**Docket # 2026-2028-WMPs**

## RE: Reply Comments of San Diego Gas & Electric Company on its 2026-2028 Wildfire Mitigation Plan R1

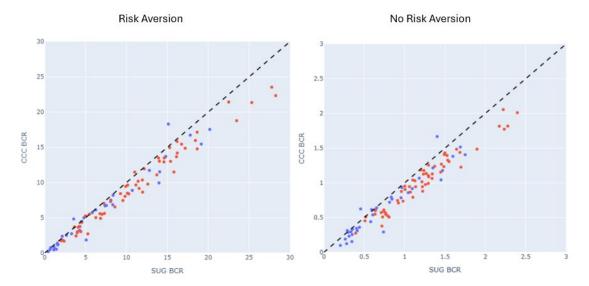
While MGRA acknowledges that SDG&E provides a transparent explanation of its CCC effectiveness methodology in Section 6.1.3.1.5, it disagrees with the inclusion of 'Evidence of Heat' recordable events alongside CPUC Reportable Ignitions. MGRA argues that Evidence of Heat events should be excluded solely because they do not meet the formal CPUC reportable ignition criteria. However, this position overlooks the fact that 'Evidence of Heat' events are collected by SDG&E field teams using the same protocols, reviewed with the same rigor, and treated with the same operational significance as CPUC Reportable Ignitions. These events pose potential ignition risks and are reasonable to consider when developing risk reduction strategies.

The following two images depict Evidence of Heat events recorded within SDG&E's service territory. The image on the left shows an ignition-related incident involving an animal contact with CALFIRE-exempt equipment in a crossarm mounted on a steel pole. The image on the right captures a wire-down event that landed on turf (artificial grass) rather than dry grass. Had the wire contacted dry vegetation, the outcome could have escalated into a CPUC Reportable Ignition.

Contrary to MGRA's assertions, these Evidence of Heat events provide valuable insights into ignition risk and asset vulnerability. They play a critical role in informing SDG&E's long-term grid hardening strategy by highlighting conditions that, while not meeting CPUC's formal reporting criteria, still represent significant operational and safety concerns. It is reasonable to include these risk events to inform an overall understanding of the effectiveness of covered conductor or any other mitigation strategy.

While SDG&E maintains that including Evidence of Heat events in mitigation effectiveness calculations is valuable, SDG&E's mitigation effectiveness calculations presented in Section 6.1.3.1.5 also include a scenario in which CCC effectiveness is evaluated using only CPUC Reportable Ignitions. Under this approach, the documented effectiveness rate for covered conductor increases from 61.71% (when including Evidence of Heat data) to 70.11% (based only on CPUC reportable ignitions). Similarly, the effectiveness of undergrounding improves from 98.52% to 99.48% when calculated exclusively with CPUC Reportable Ignitions.
